ADDENDUM NO. 1
CITY OF DERMOTT
WATER LINE REPLACEMENT AND EXTENSIONS
10 January 2024

Replace sheets 2 – 6, 16, 22 – 25, and 37 – 38 with the attached sheets. (Revised placement of insertion valves and connection at tank).

**CITY OF DERMOTT
WATER SYSTEM REPLACEMENT
VALVES TO BE CUT IN
GENERAL LAYOUT**

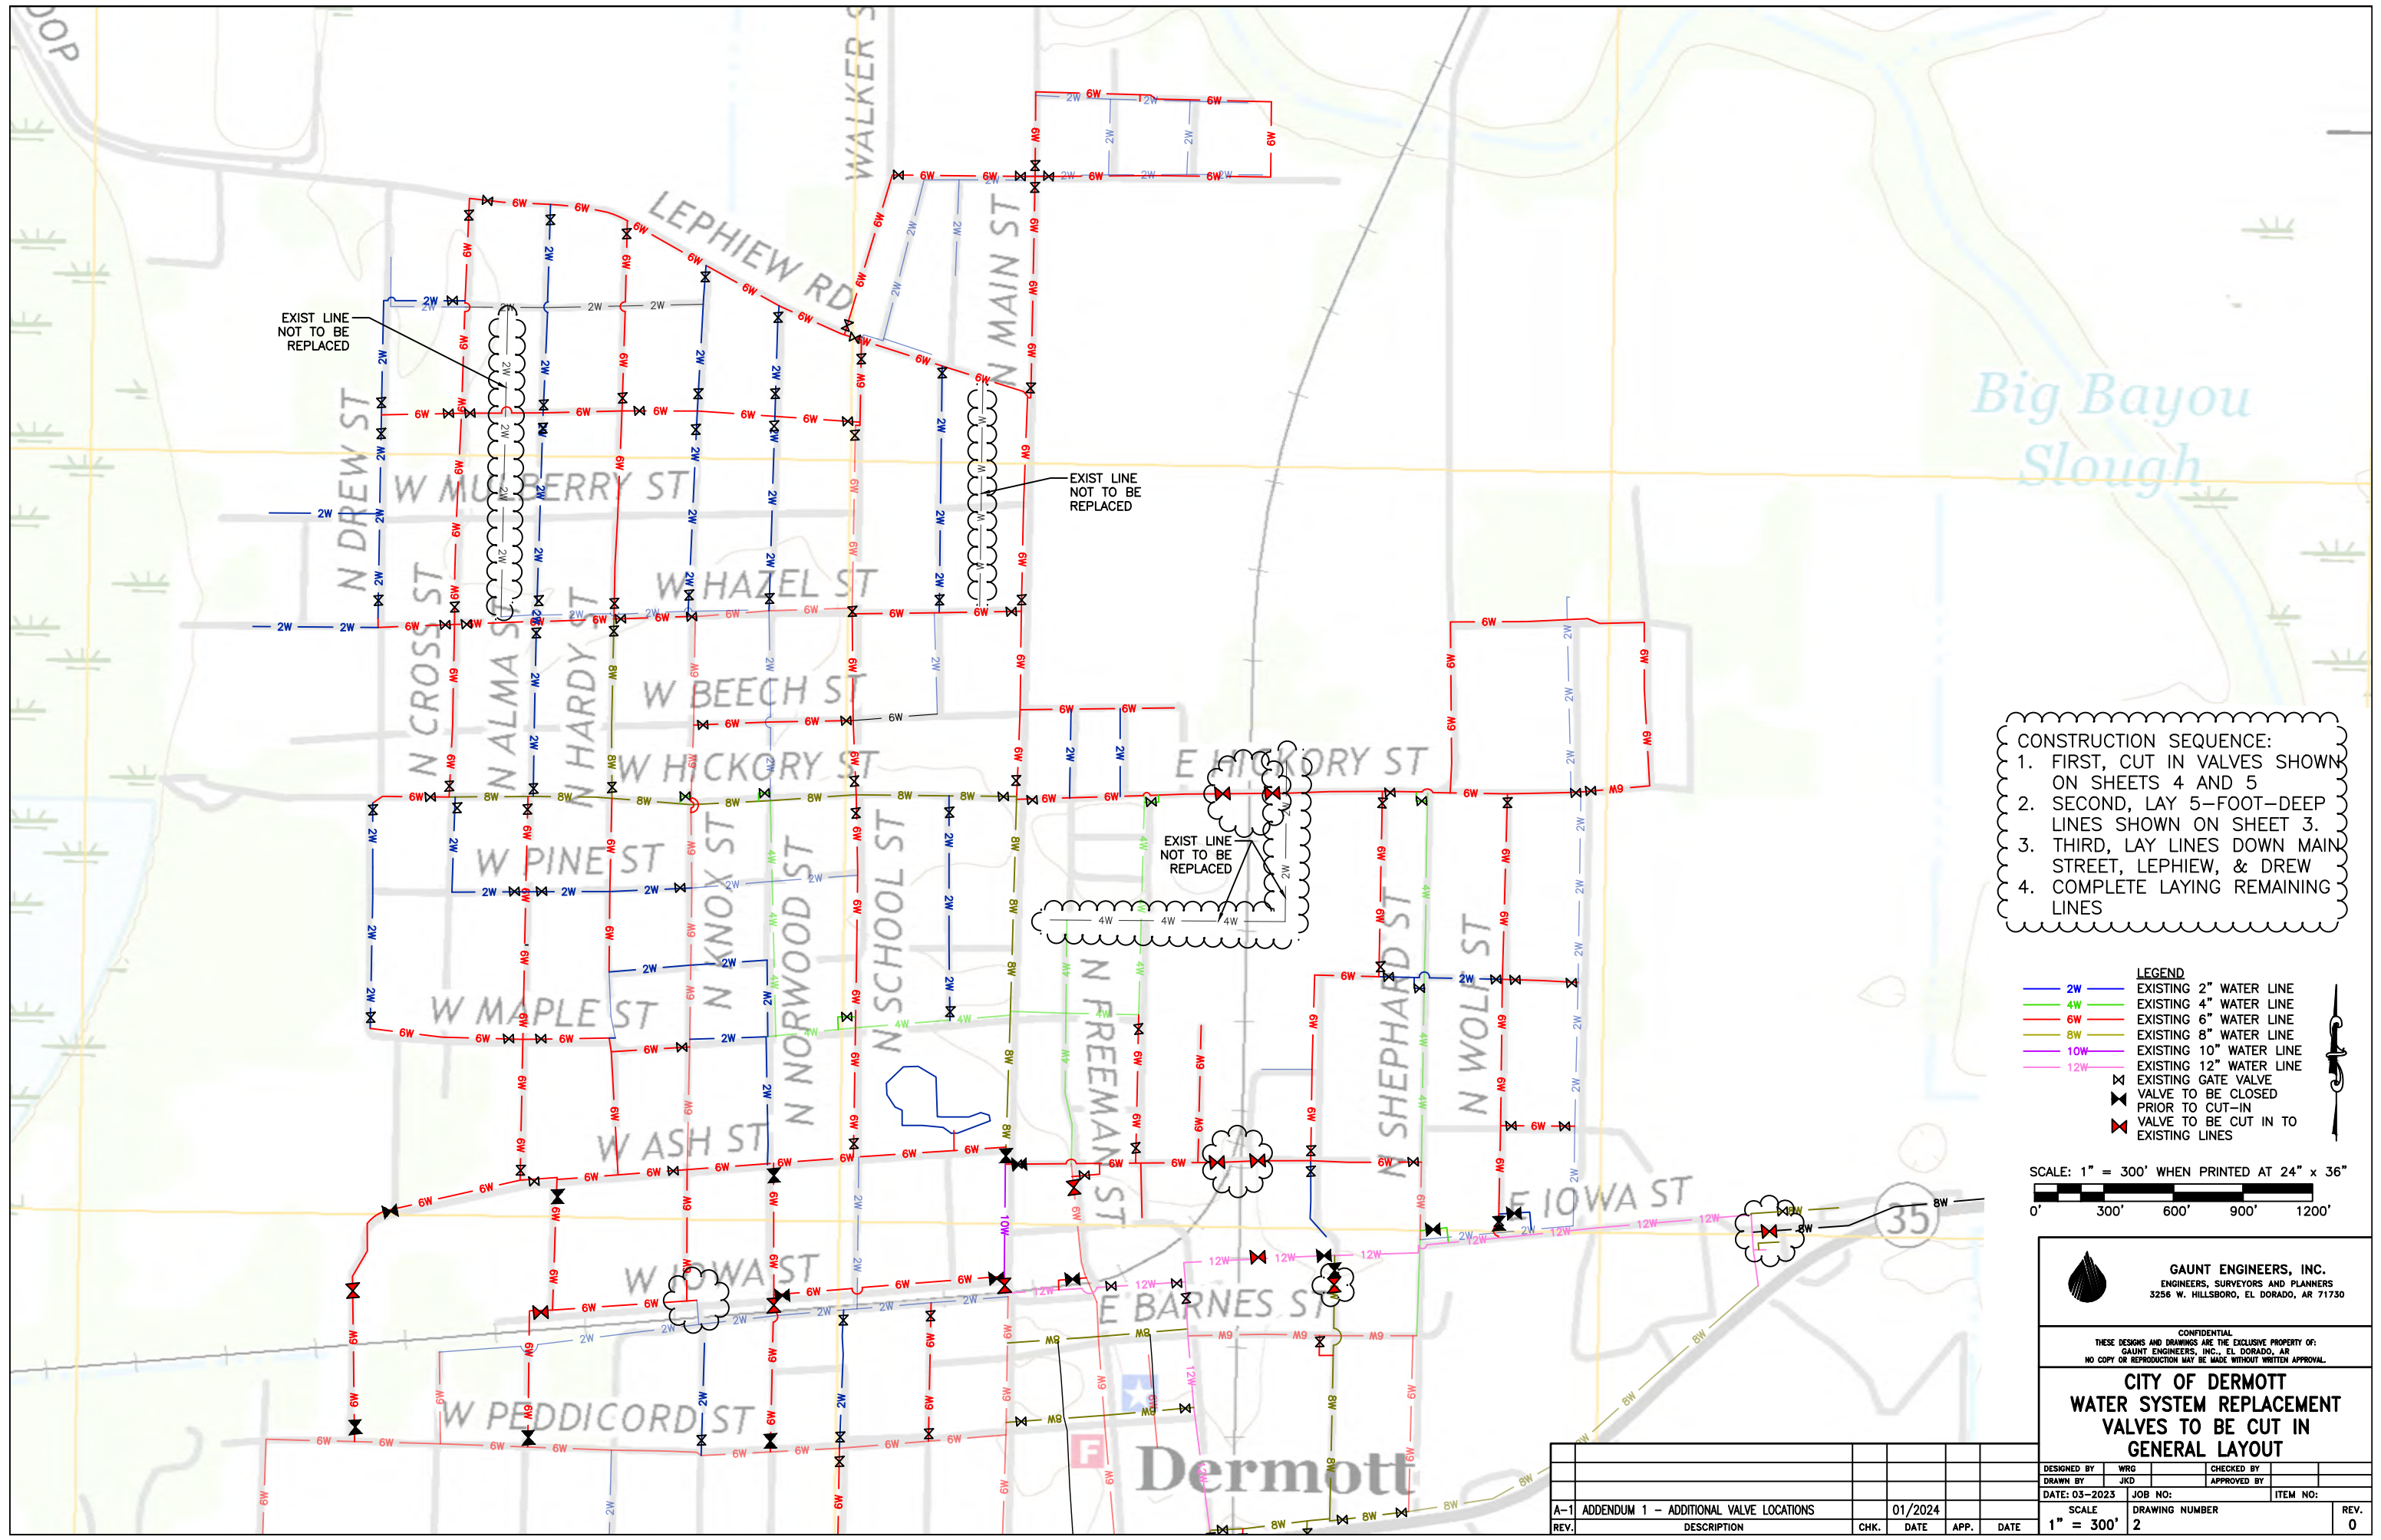
A-1 ADDENDUM 1 - ADDITIONAL VALVE LOCATIONS	01/2024			
REV.	DESCRIPTION	CHK.	DATE	APP. DATE

**CITY OF DERMOTT
WATER SYSTEM REPLACEMENT
LINES TO BE PLACED AT
MIN. 5-FOOT DEPTH**

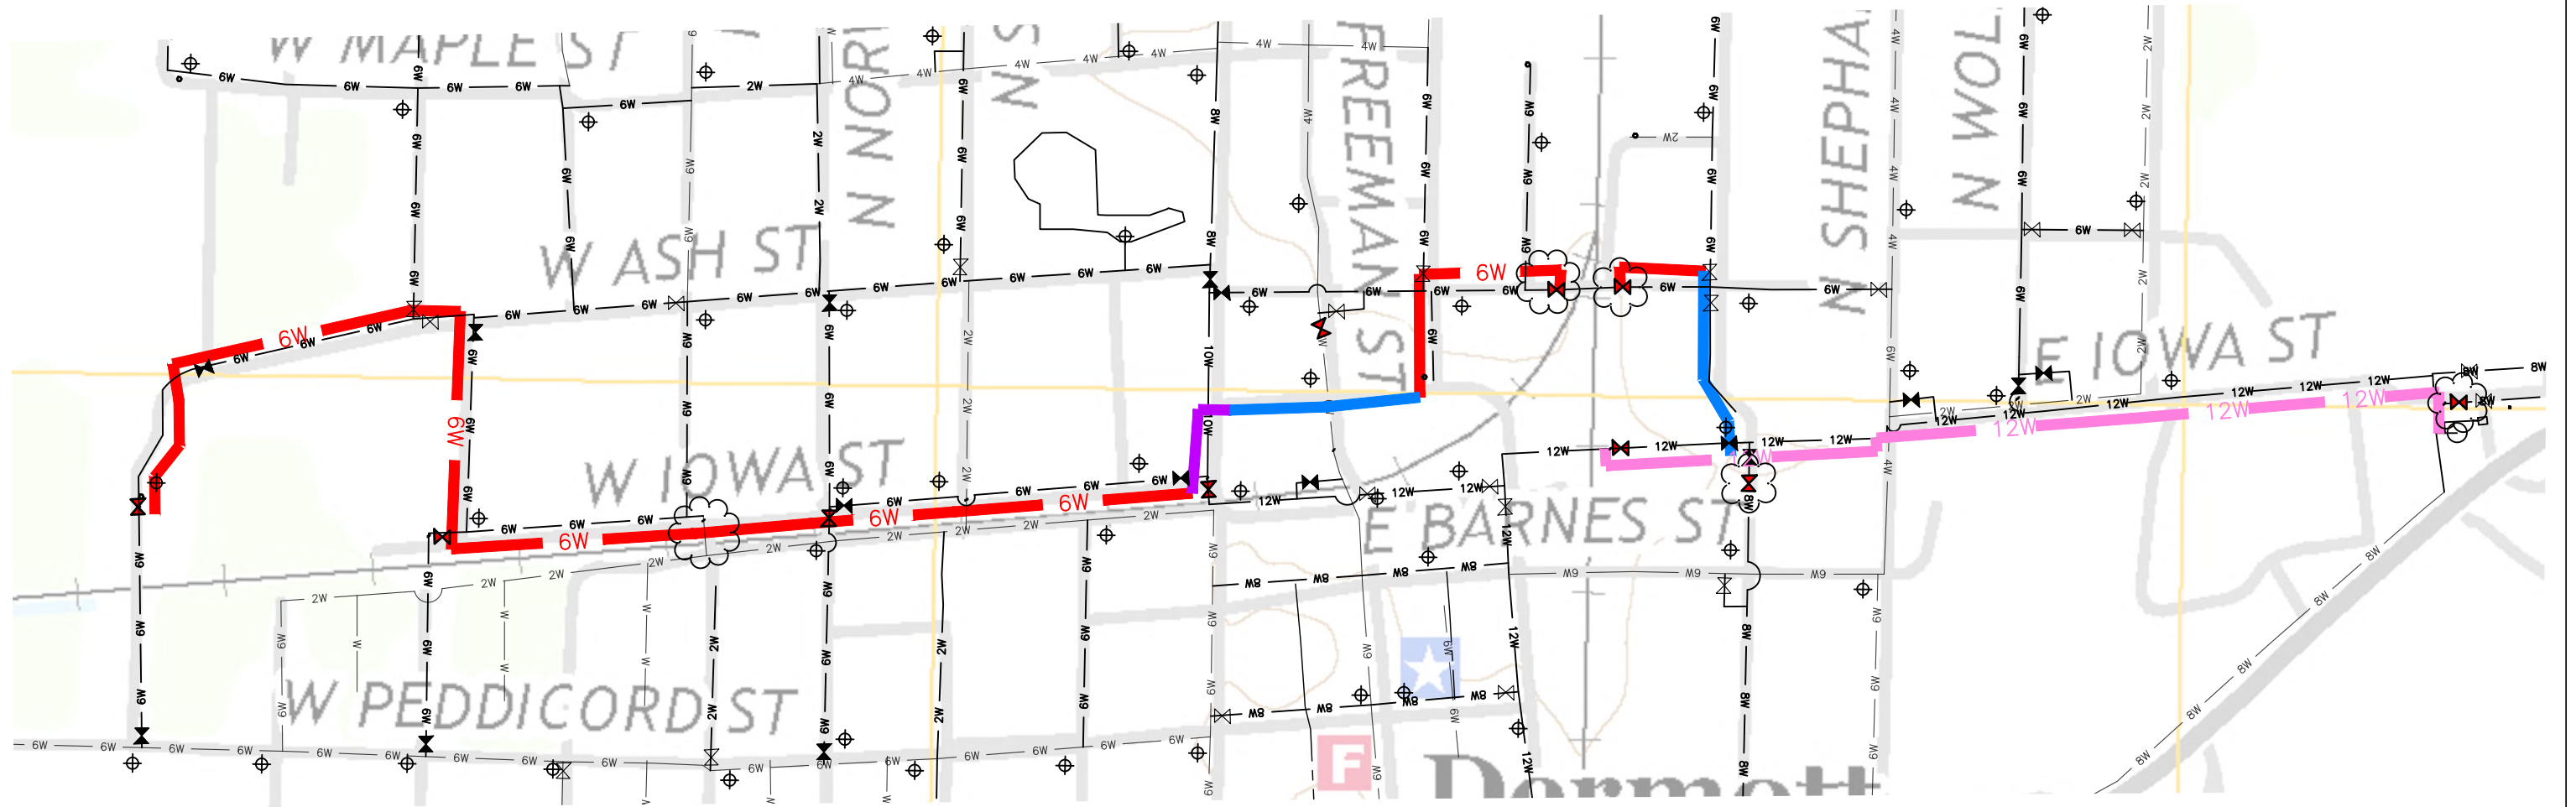
DESIGNED BY	WRG	CHECKED BY	
DRAWN BY	JKD	APPROVED BY	
DATE: 03-2023	JOB NO:	ITEM NO:	
A-1 ADDENDUM 1 - REVISED VALVE LOCATIONS	01/2024	SCALE	DRAWING NUMBER
REV.	DESCRIPTION	CHK.	DATE APP. DATE
		1" = 200'	3
			REV. 0

**CITY OF DERMOTT
WATER SYSTEM REPLACEMENT
VALVES TO BE CUT IN**

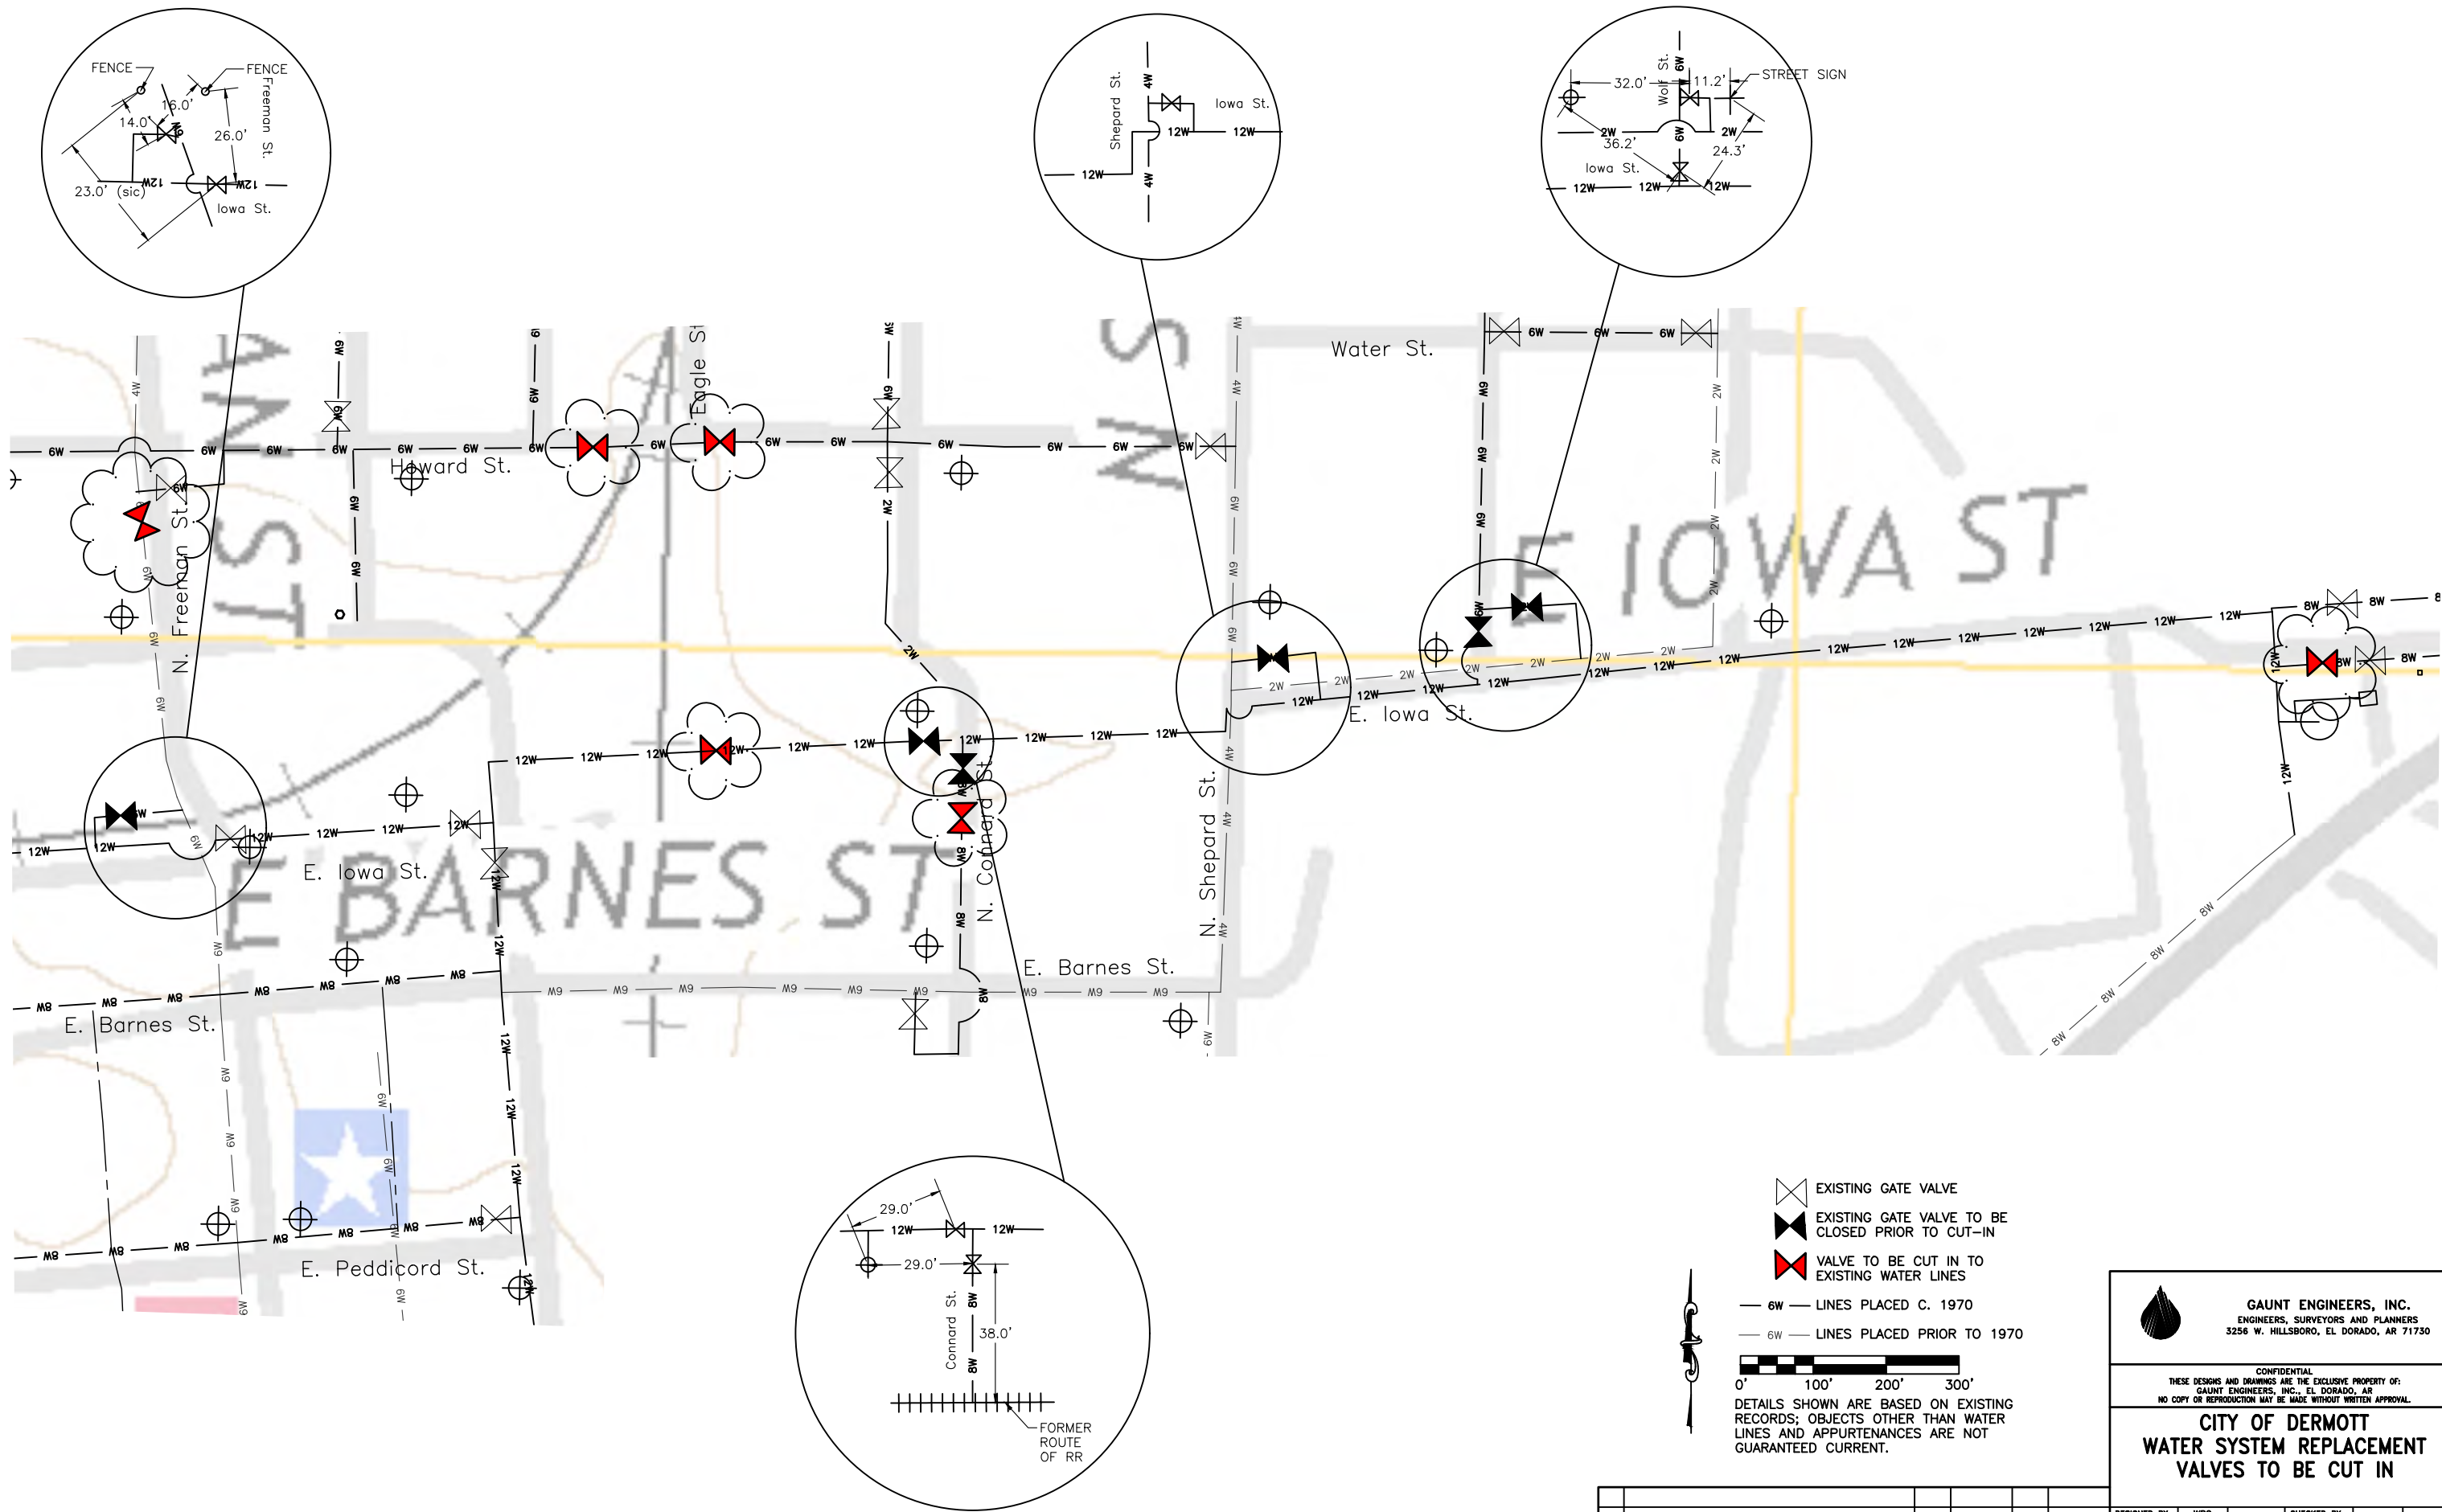
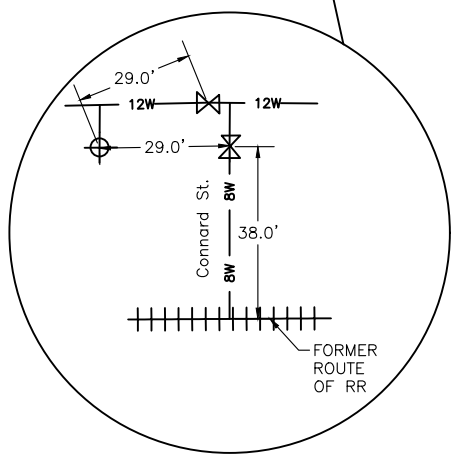
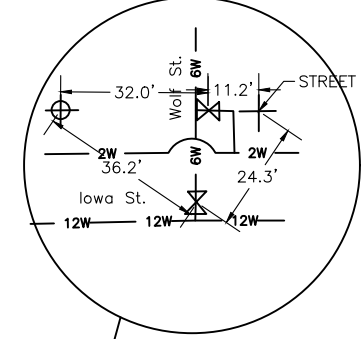
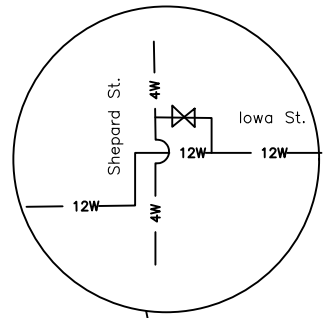
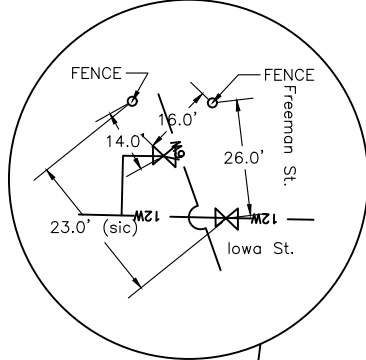
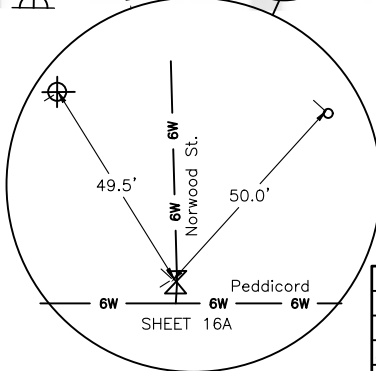
DESIGNED BY	WRG	CHECKED BY	
DRAWN BY	JKD	APPROVED BY	
DATE: 03-2023	JOB NO:	ITEM NO:	
A-1 ADDENDUM 1 - ADD INSERTION VALVE	01/2024	SCALE	DRAWING NUMBER
REV.	DESCRIPTION	CHK.	DATE
		APP.	DATE
